**SUBJECT:** R-Area Groundwater (NBN) Biennial Effectiveness Monitoring Report in Support of R-Area Operable Unit (U) January 2021 through December 2022 (SRNS-RP-2023-00758, Revision 1, June 2024) and Savannah River Site's Responses to the Regulatory Comments on the Revision 0 Document, SEMS Number: 95

1. R-Area Groundwater (NBN) Biennial Effectiveness Monitoring Report in Support of R-Area Operable Unit (U) January 2021 through December 2022 (SRNS-RP-2023-00758, Revision 1, June 2024) SEMS Number 95
2. SRS Response to the U.S. Environmental Protection Agency's Comments on the R-Area Groundwater (NBN) Biennial Effectiveness Monitoring Report in Support of R-Area Operable Unit (U) January 2021 through December 2022, SEMS Number: 95, SRNS-RP-2023-00758, Revision 0, August 2023
3. SRS Responses to the South Carolina Department of Health and Environmental Control's Comments on the R-Area Groundwater (NBN) Biennial Effectiveness Monitoring Report in Support of R-Area Operable Unit (U) January 2021 through December 2022, SEMS Number: 95, SRNS-RP-2023-00758, Revision 0, August 2023

Revised Figure 9.(Figure 8 in Revision 1) RAGW Combined Western, ISD and Eastern Tritium Plumes Cross-Section 2022

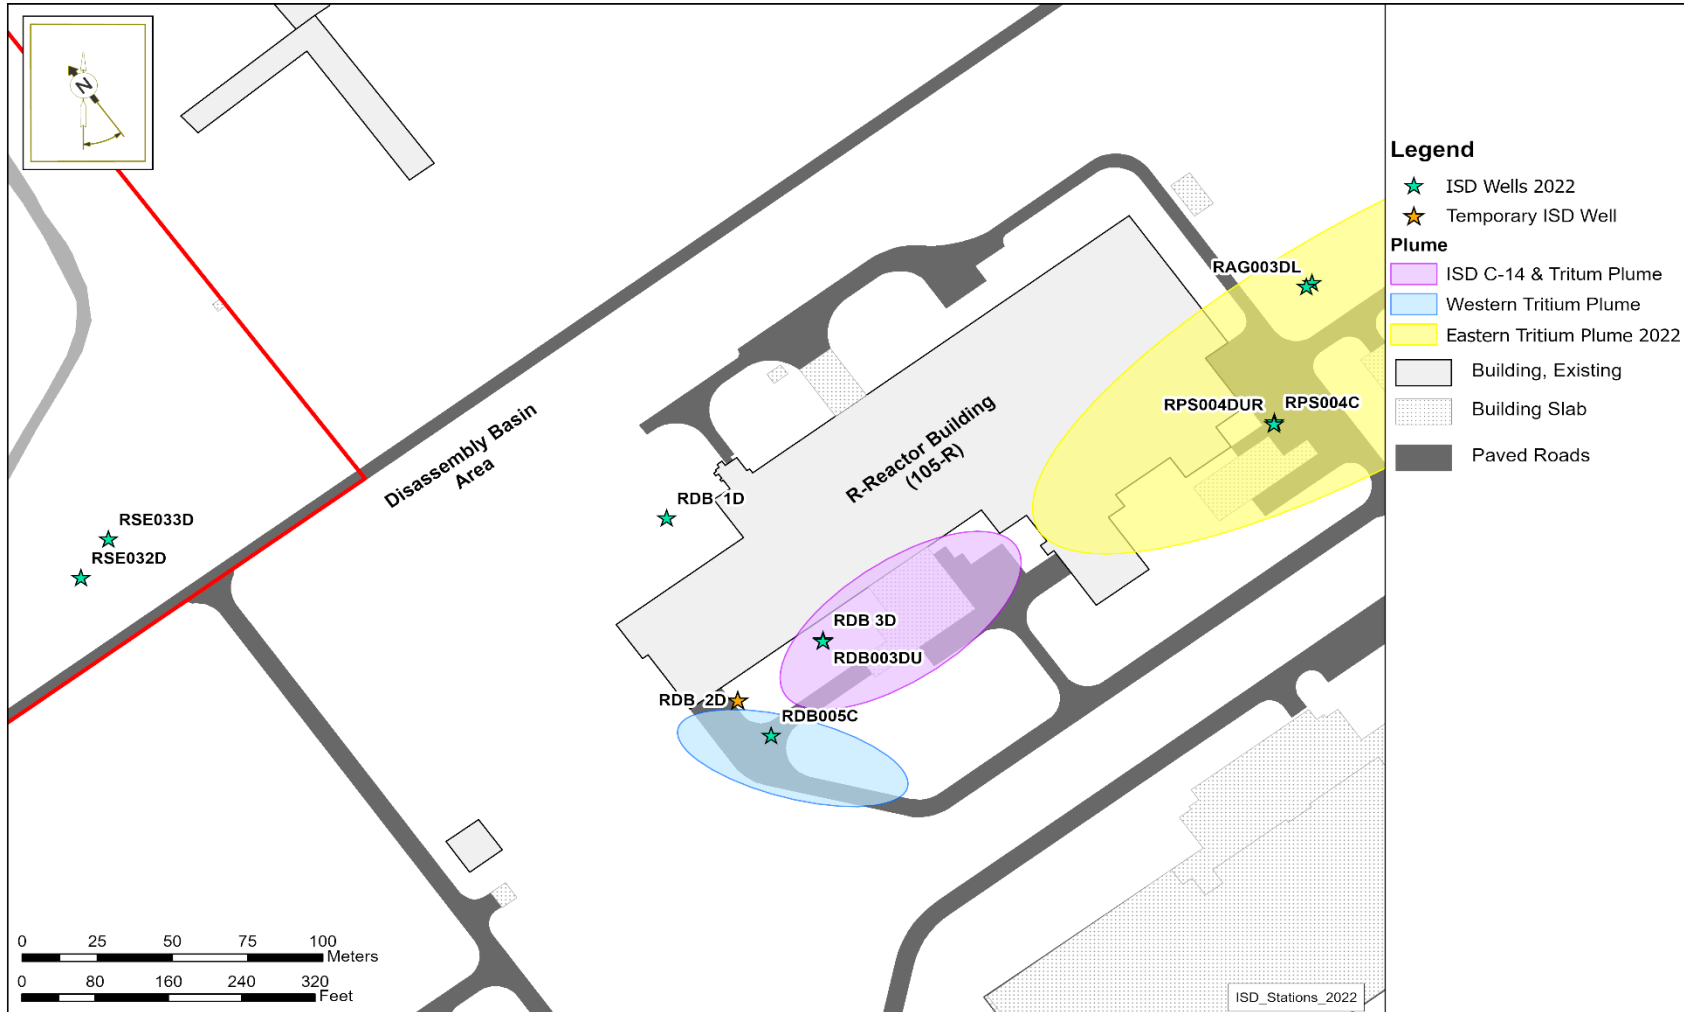
1. It is unclear whether data gaps exist in the lateral extent of tritium contamination. The Eastern and Western Tritium Plumes are shown on Figure 3, RAGW Monitoring Stations and 2022 Groundwater Plumes, as two distinct and separate plumes; however, there are no monitoring wells located between the two plumes to provide lateral delineation. Also, according to the A – A' cross-section stratigraphic profile in Figure 9, R-Area Cross-Section with RAGW Eastern Tritium Plume 2022, no wells are shown west of RPS004C to delineate the plume. Furthermore, a figure with a cross-section showing both the Eastern and Western Tritium Plumes is not presented to show whether the plumes are distinct and separate. *Please revise the EMR to discuss the apparent data gap in the lateral delineation of tritium plumes and include a cross-section that shows both the Eastern and Western Tritium Plumes.*

22. Figures 8 through 11, Cross Sections, pages 27 through 30. Please add a cross section of the Western Tritium Plume along A-A'.

**Regardless, in future RAGW EMRs, the Cross Section A – A' will include data from wells RDB 2D, RDB 3D, RDB003DU and RDB005C, depicting the Eastern and Western tritium plumes essentially connected by the new in-situ decommissioning (ISD) tritium plume centered on RDB 3D as indicated in the revised Figure 8 Cross Section A – A' figure (attached). This is a more appropriate depiction for Cross Section A – A', and also a more conservative depiction as there are no sample points between RDB 3D and RPS004C, as noted by the reviewer. The revised Figures 3, 4, and 5 (attached) have also been updated to show this near connection of the Eastern, Western, and ISD tritium plumes.**

**Figure 9 (now referred to as Figure 8) has been revised (attached) to include all three tritium plumes along Cross Section A-A'.**

Revised Figure 6 (Now Figure 7 in Revision 1)

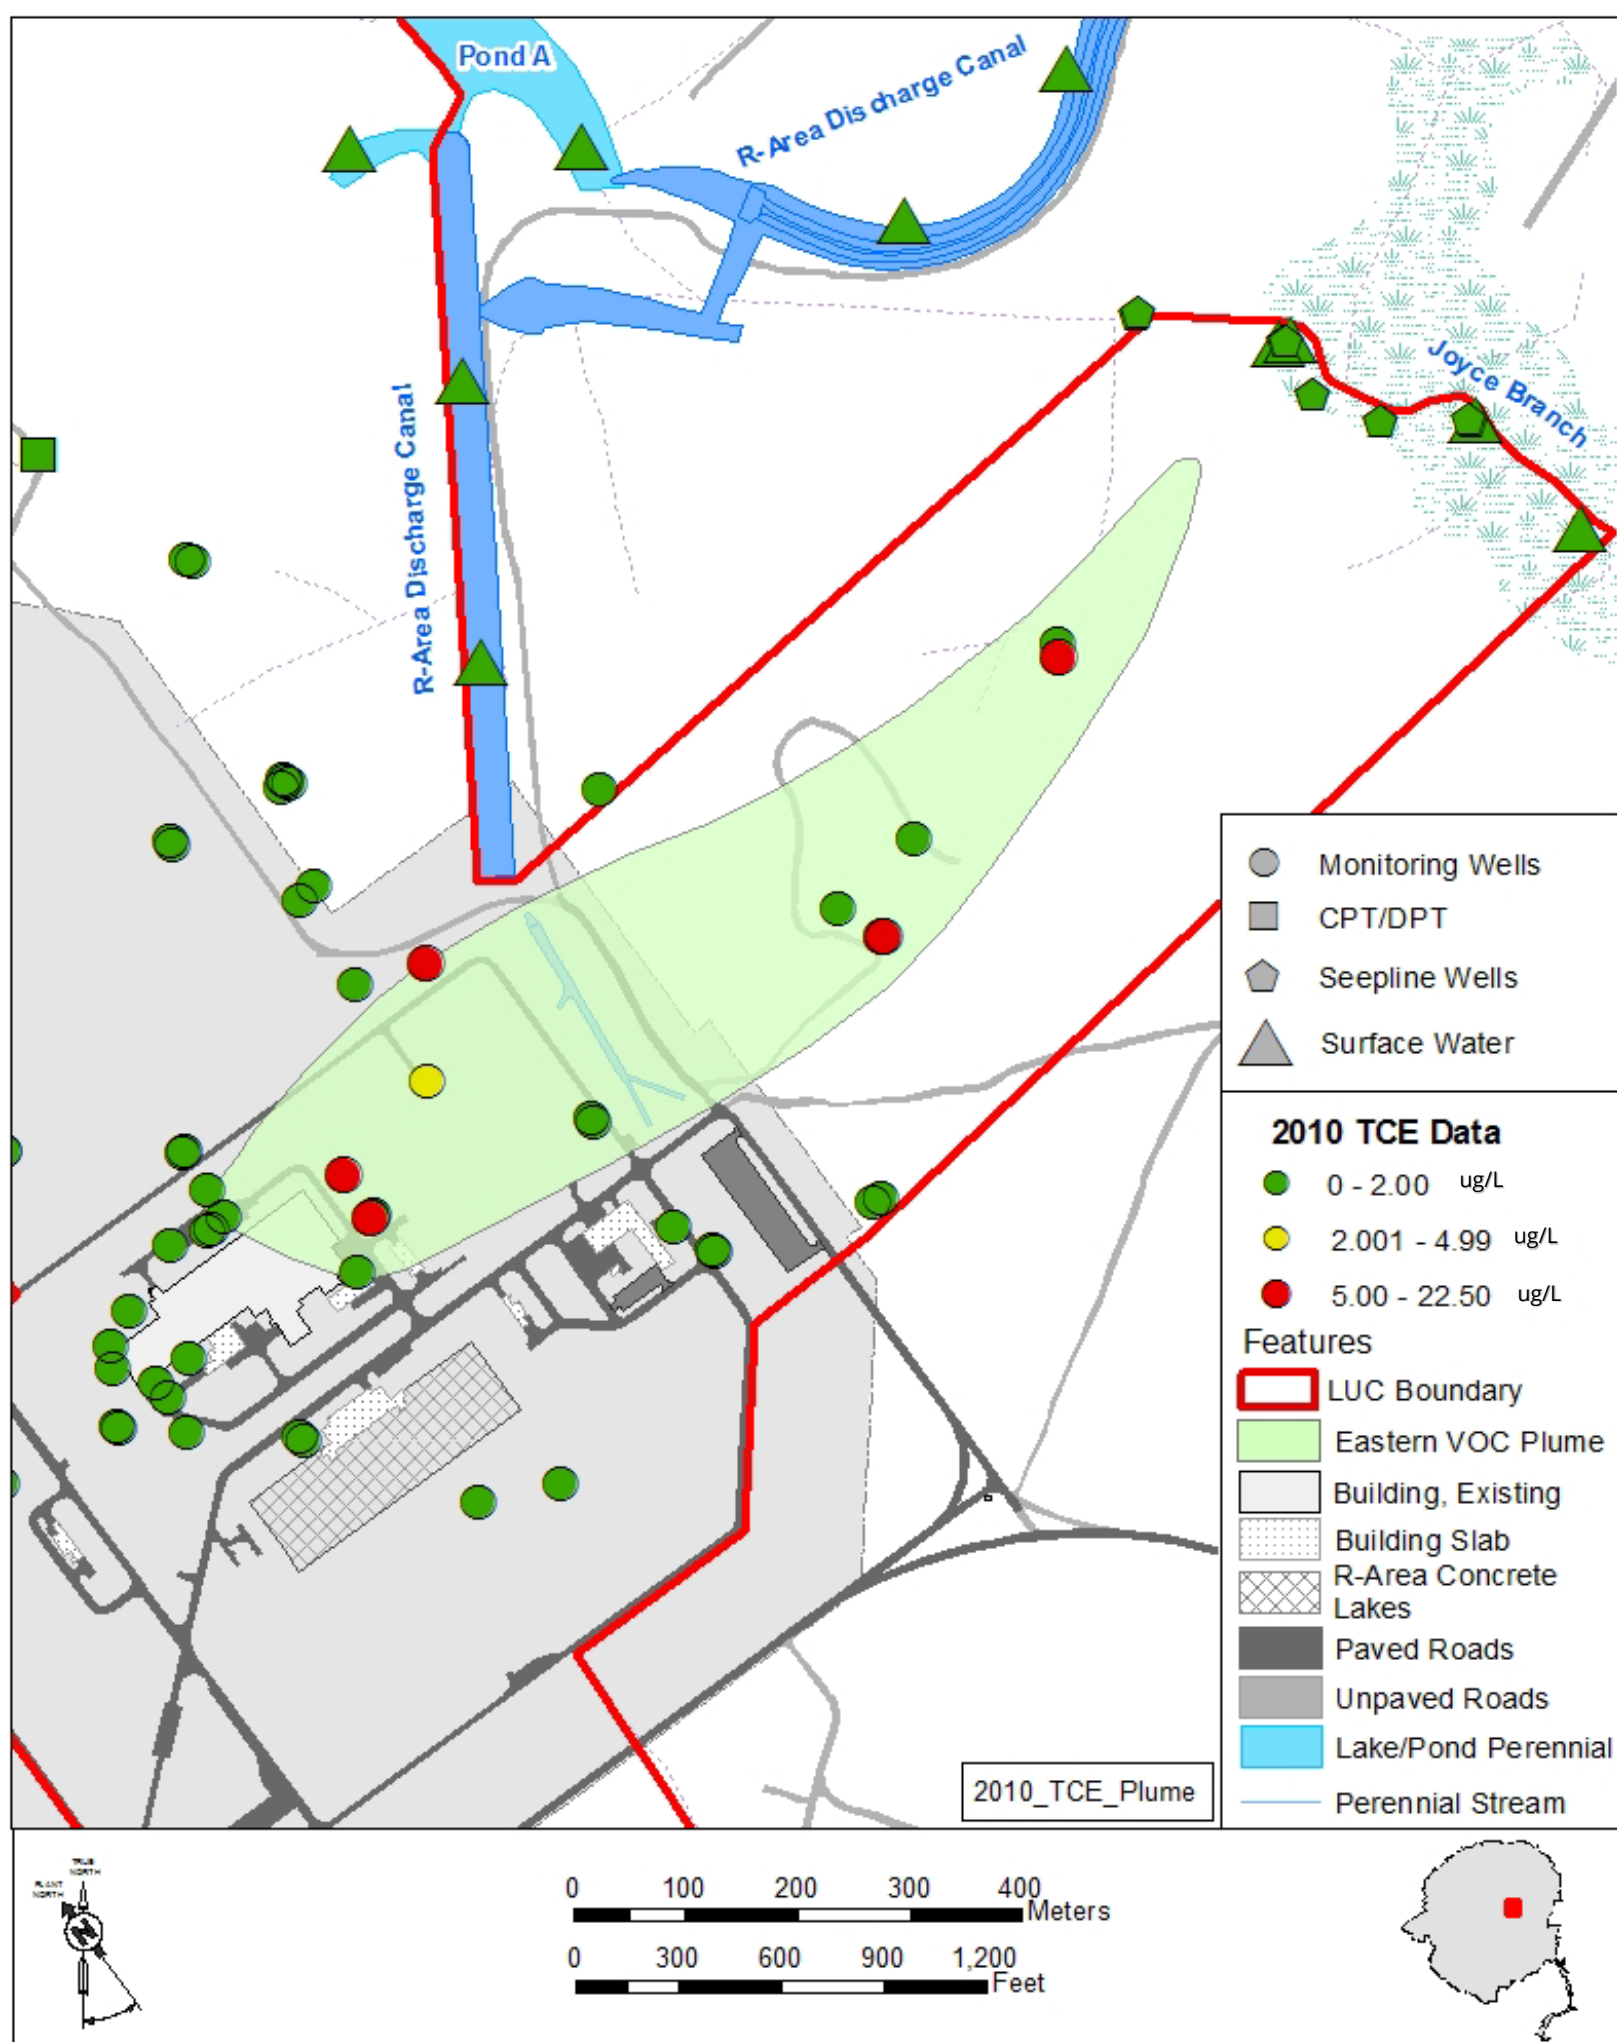
21. Figure 6, RAGW Eastern VOC Plume 2010 Data, page 25. The legend identifies the circles on the figure as monitoring well locations, but the concentrations are provided in units of µg/kg instead of µg/L. Please revise the figure appropriately.

**Figure 6 (now referred to as Figure 7) has been revised (attached) to have the correct units (ug/L) for the well data.**

Revised Figure 3

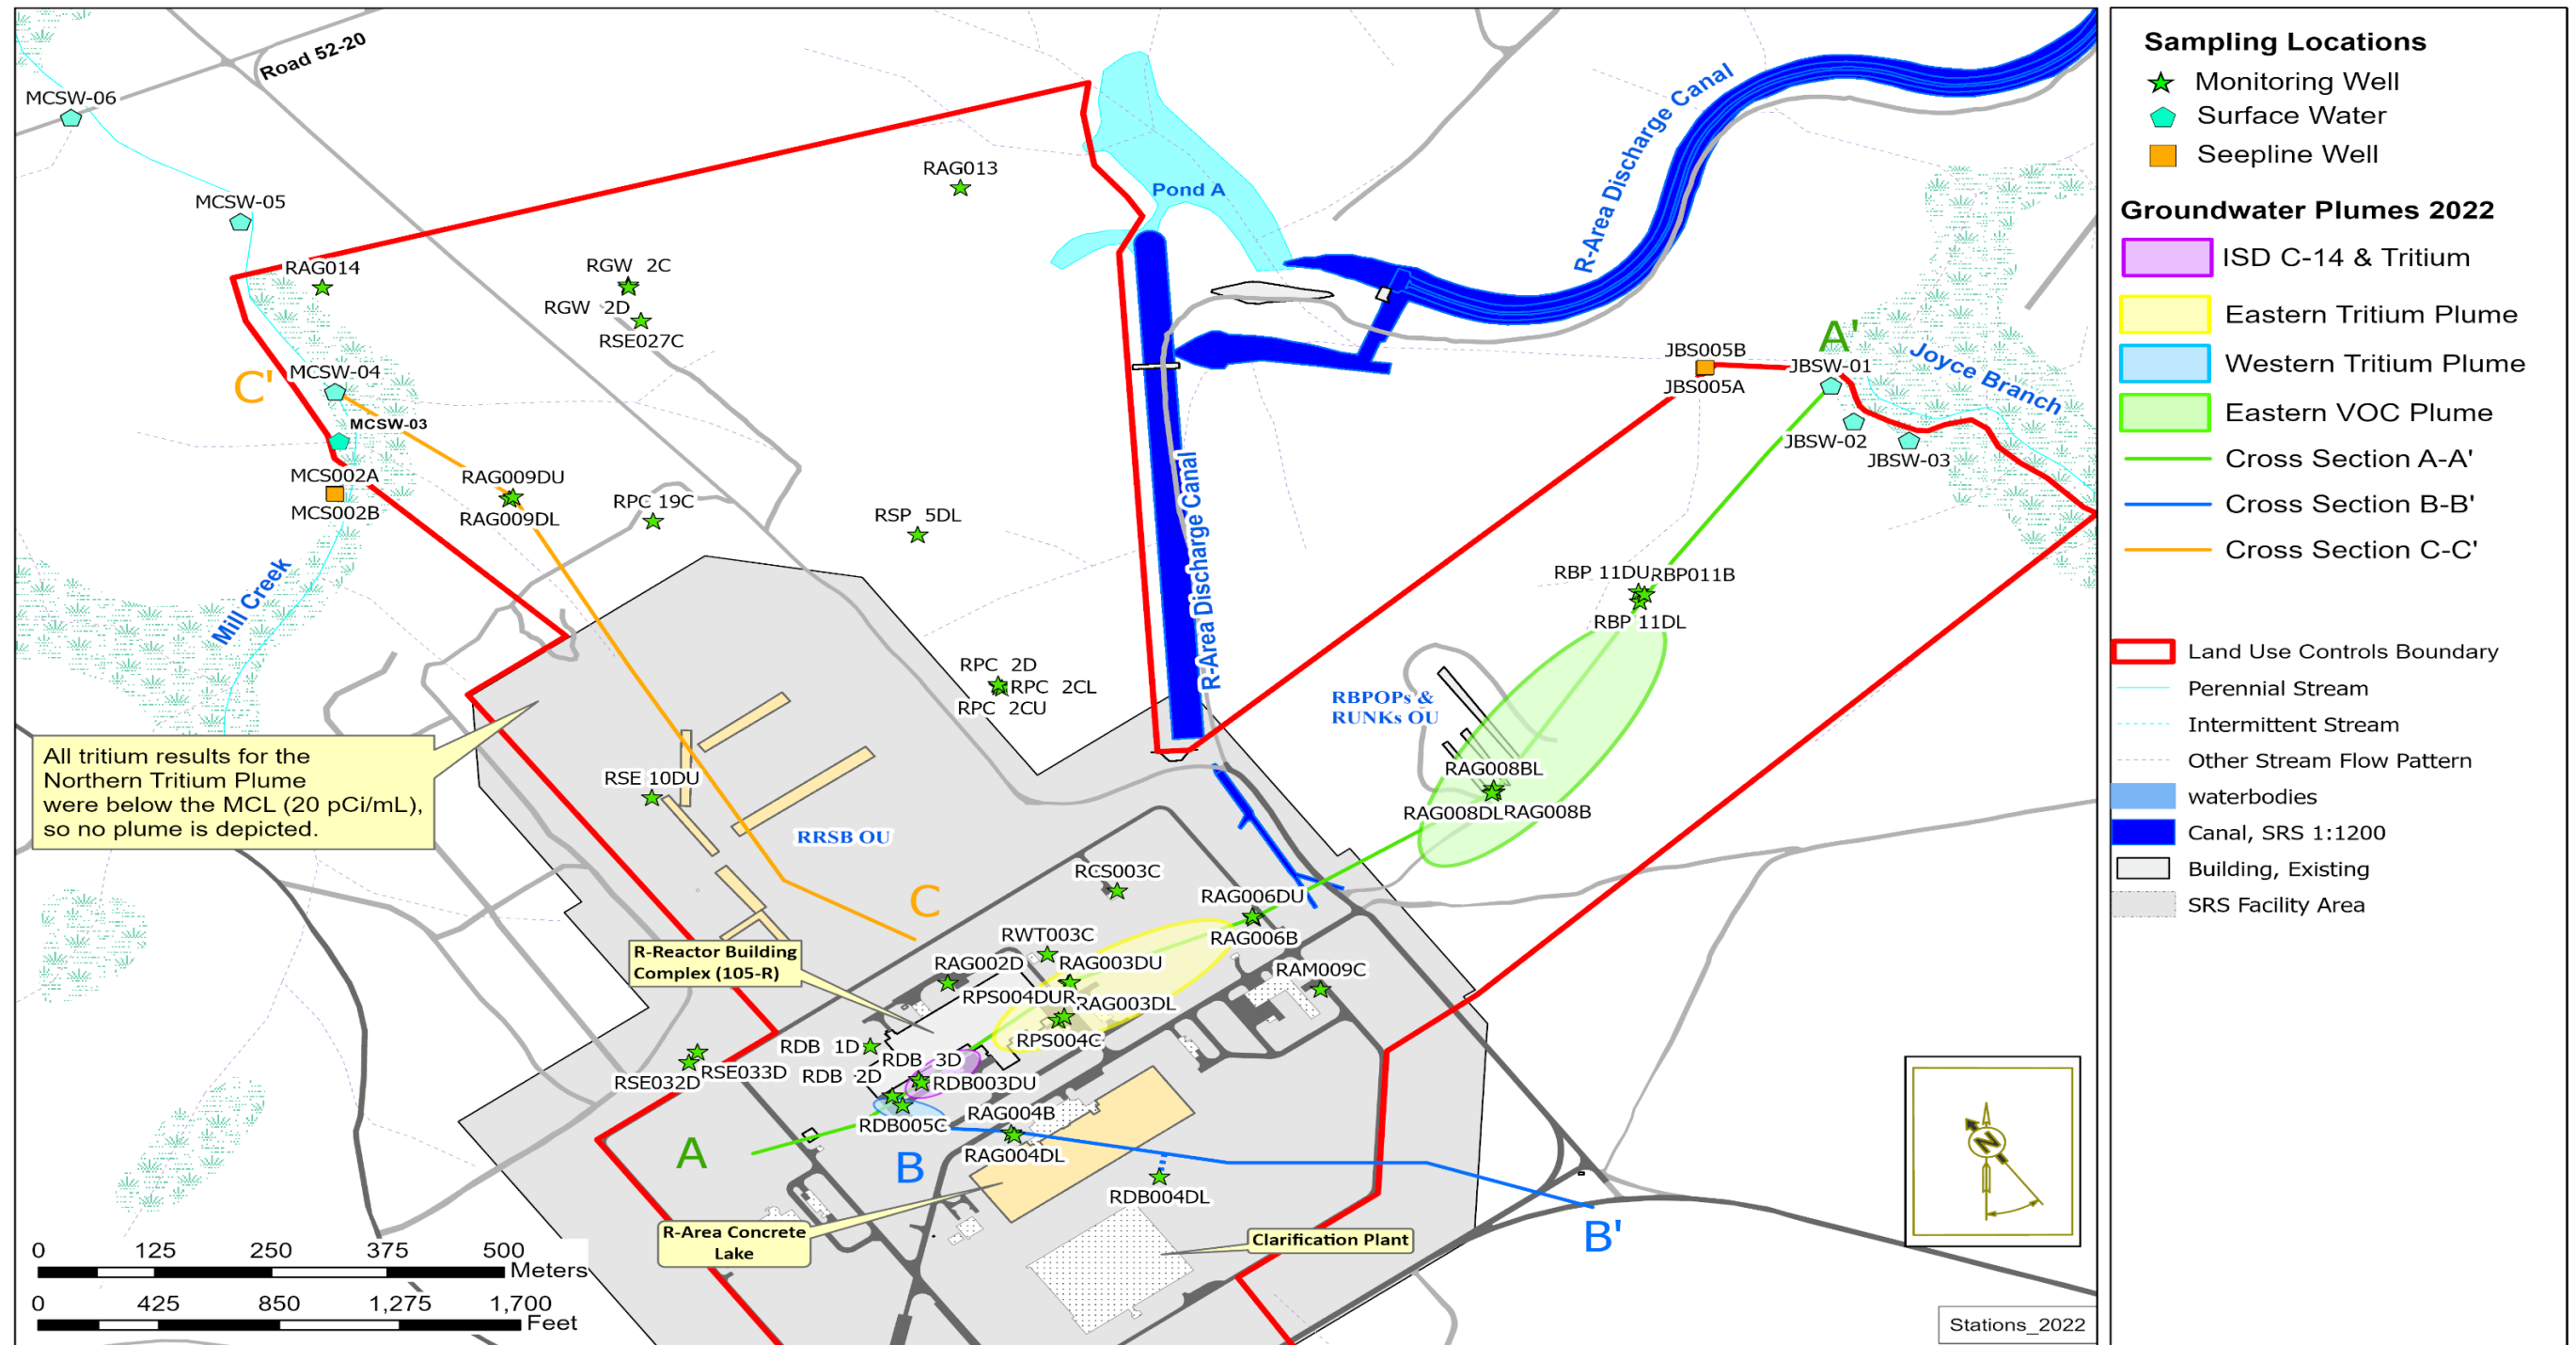
- 5. Figure 3, RAGW Monitoring Stations and 2022 Groundwater Plumes, Page 21 of 40:** It is unclear if the Western Tritium Plume includes the ISD tritium plume that surrounds wells

RDB 3D/RDB 3DU. The legend for Figure 3 defines two tritium plumes, one surrounding wells RDB 3D/RDB 3DU and one surrounding well RDB005C, collectively referenced as the Western Tritium Plume in the legend; however, according to Figure 4, ISD Monitoring Wells (2022) and Figure 5, Five ISD Monitoring Wells Samples Annually (2018 through 2022), the Western Tritium Plume surrounds well RDB005C and the ISD Carbon-14 and Tritium Plume surrounds wells RDB 3D/RDB 3DU. *Please revise Figure 3 or Figures 4 and 5 to consistently show the extent of the Western Tritium Plume.*

7. **Figure 3, RAGW Monitoring Stations and 2022 Groundwater Plumes, Page 21 of 40:** There is a duplicate well identifier for well RDB 2D. *Please remove the duplicate well identifier.*

19. Figure 3, RAGW Monitoring Stations and 2022 Groundwater Plumes, page 21. Figure 3 shows the Western Tritium Plume as two distinct plume areas centered around RDB 005C and RDB 3. In Figures 4 and 5, the two plume areas are differentiated as the Western Tritium Plume around RDB 005C and the ISD C-14 & Tritium Plume around RDB 3. The text of the document discusses the two plume areas separately in Section 5. If the report text and Figures 4 and 5 are correct in differentiating between the two plumes, then Figure 3 should be revised to be consistent with the rest of the document.

20. Figure 3, RAGW Monitoring Stations and 2022 Groundwater Plumes, page 21. The figure appears to be missing a well ID label for RPC 2CL, which is presumably located near RPC 2D and RPC 2CU based on the UTM-N and UTM-E locations provided in Table 1.

**Figures 4 and 5 correctly depict well RDB005C in the Western Plume and wells RDB 3D/RDB003DU in the ISD Carbon-14 and Tritium Plume. Figure 3 incorrectly showed these wells as part of the Western Plume. Figure 3 was corrected (see attached) to show well RDB005C in the Western Plume and wells RDB 3D/RDB003DU in the ISD Carbon-14 and Tritium Plume consistent with Figures 4 and 5.**

**The duplicate well name has been removed in the revised Figure 3 (attached).**

**Figure 3 has been revised (attached) to show 3 plume areas: 1) Western Tritium Plume; 2) ISD C-14 and Tritium Plume; and 3) Eastern Tritium Plume.**

**Figure 3 has been revised (attached) to show all 3 well labels (RPC 2D, RPC 2CU, and RPC 2CL).**
